ADL Traffic and Highways Engineering Ltd

Re: A38 DERBY JUNCTIONS PROJECT: DEADLINE 6

This letter is provided following our letter of 3 February 2020 and the subsequent hearing on 19th February. We note updates under the previous letter headings as follows:

2680-SK-22

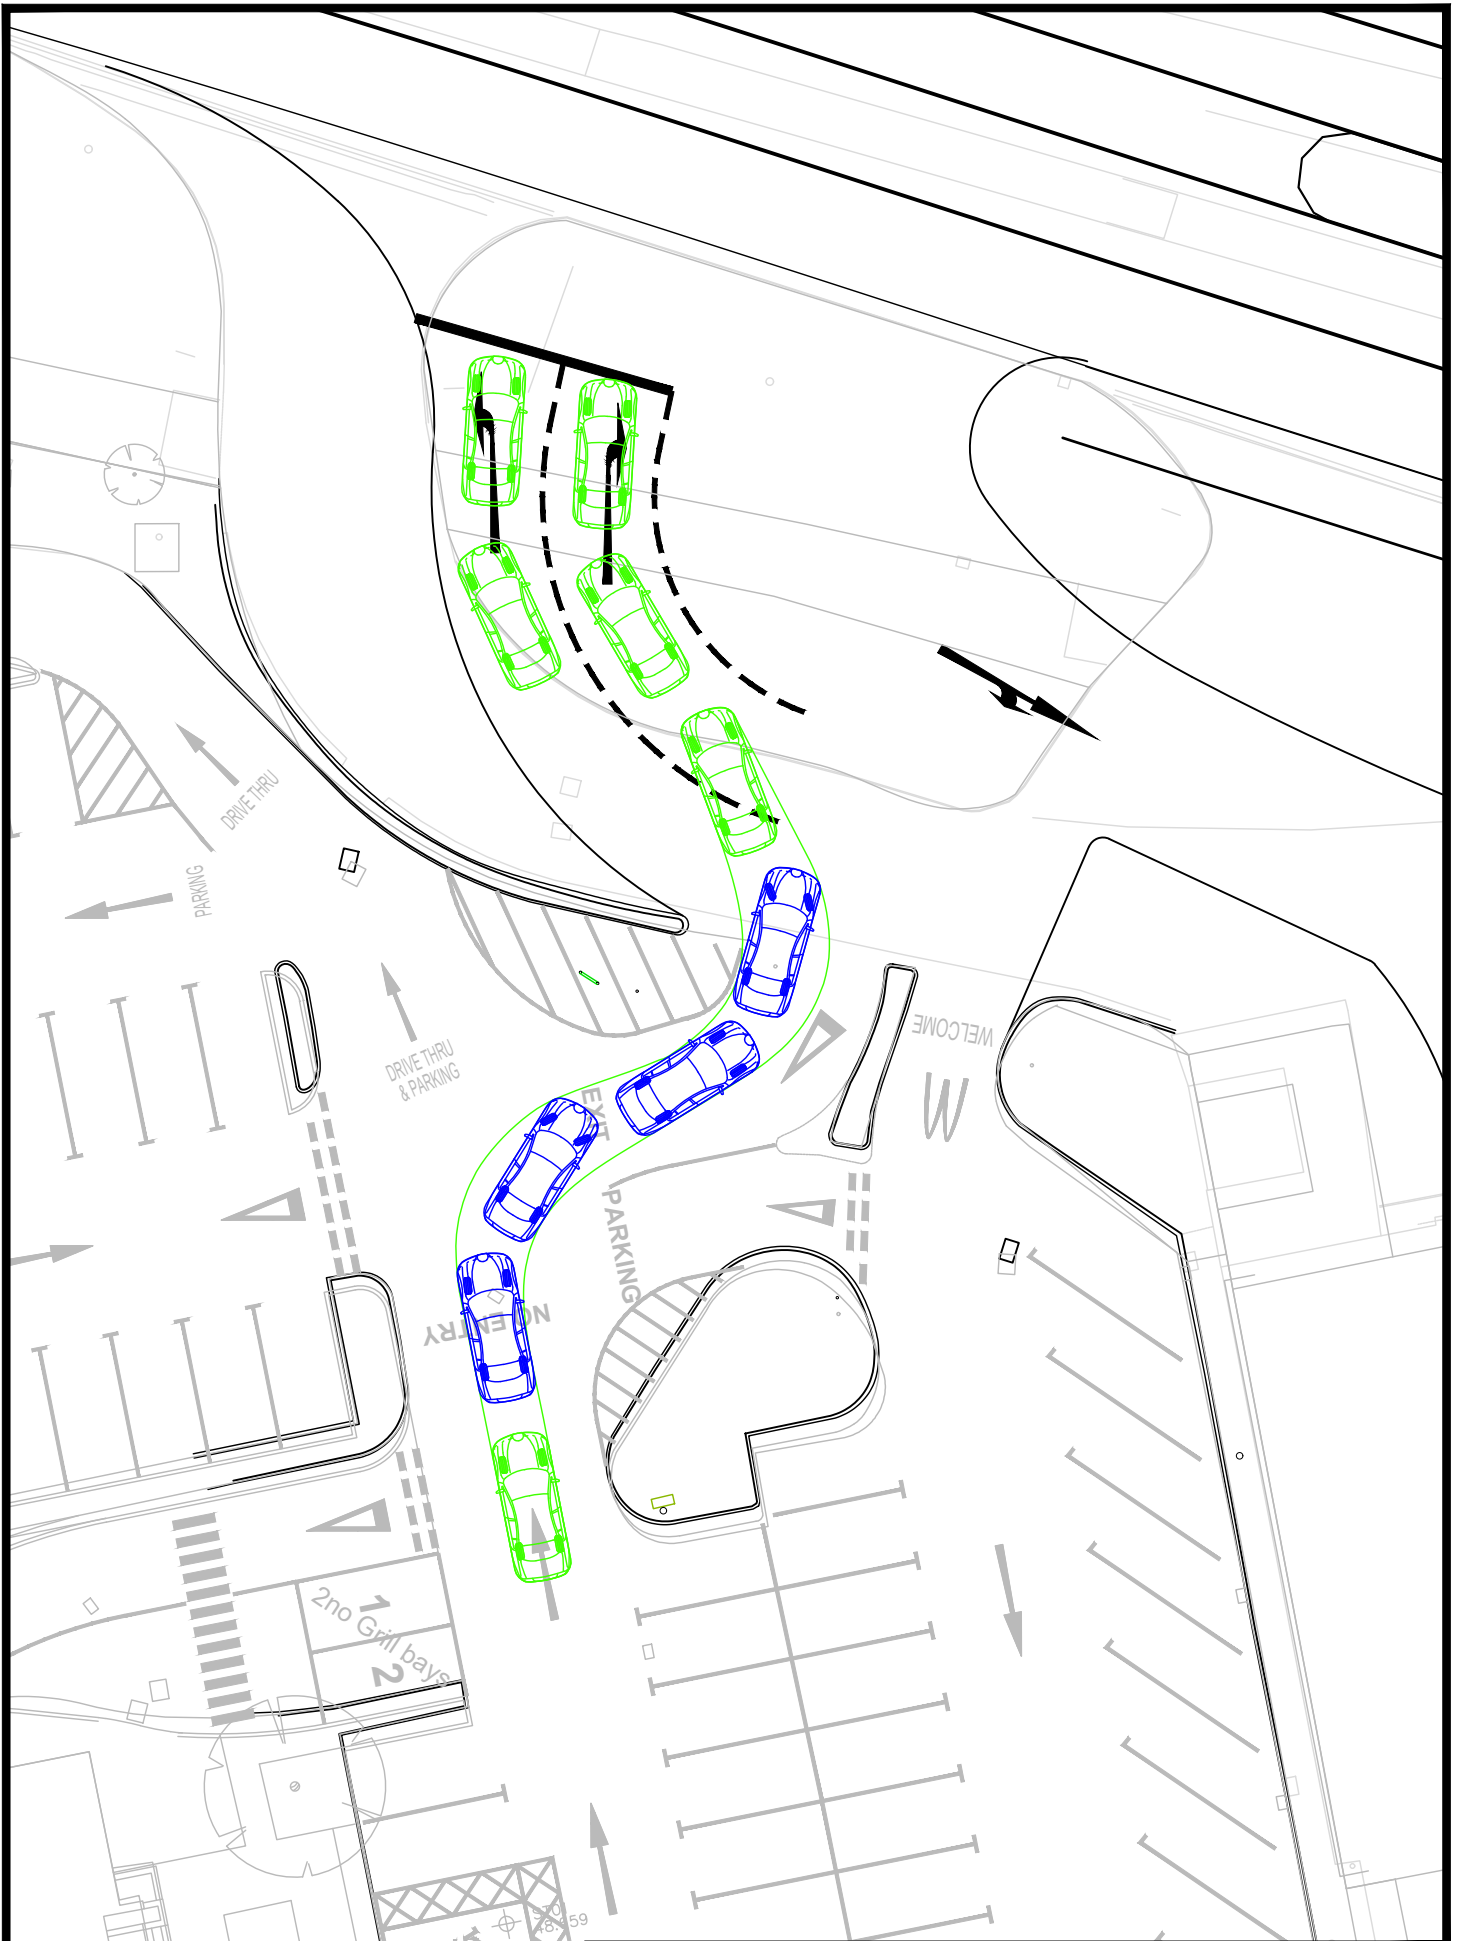
Turning to exiting traffic and referring again to attached drawing 2680-SK-22, these constraints are highlighted once more, as it would only take a queue of seven vehicles back from the stop line, before blocking the approach to the drive thru lane entrance, and eight, before the drive thru lane exit would be blocked.
